PLANNING, ZONING, & BUILDING DEPARTMENT
PZ&B Staff Combination Memorandum: Architectural Commission and Town Council

SUBJECT: ZON-23-091 (ARC-23-117) 341 PERUVIAN AVE (COMBO)

MEETING: SEPTEMBER 27, 2023 | ARCOM
OCTOBER 11, 2023 | TOWN COUNCIL

Existing South Elevation

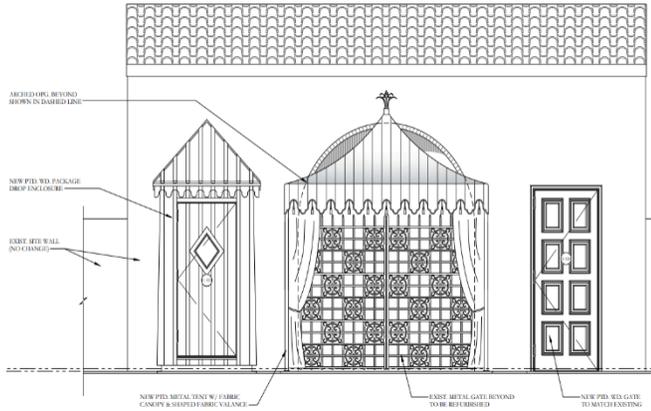
As depicted in the photos, plans, and elevations provided for the project, a large masonry wall structure with a barrel tile roof and three arches exists at the front of property along Peruvian Avenue - east of the residence's south façade. The large central arch contains a decorative metal vehicular gate, and the two flanking arches contain human-scale solid wood panel doors. No alterations are proposed to the south side of the wall.

Proposed North Elevation

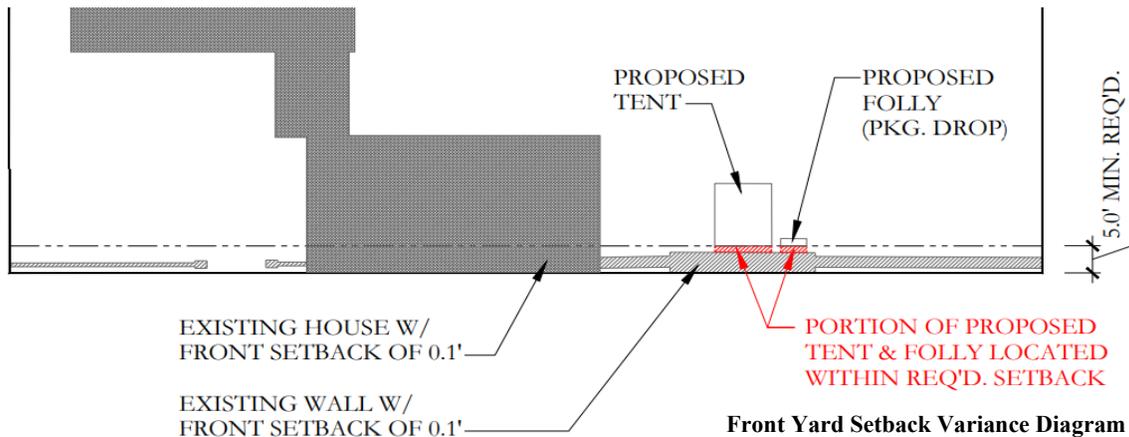
The application requests to install a new metal tent structure with a fabric canopy to provide covered vehicular parking north of the vehicular gate, and a wood package receptacle structure to the north of the east wood panel door. Detailed plan, elevation, and section drawings of the two structures are provided on Sheet A-210 of the architectural plan set. Per the drawings, the package receptacle will not be visible from Peruvian Avenue. The tent structure will be partially visible through the central arch of the wall and through the decorative metal gate.
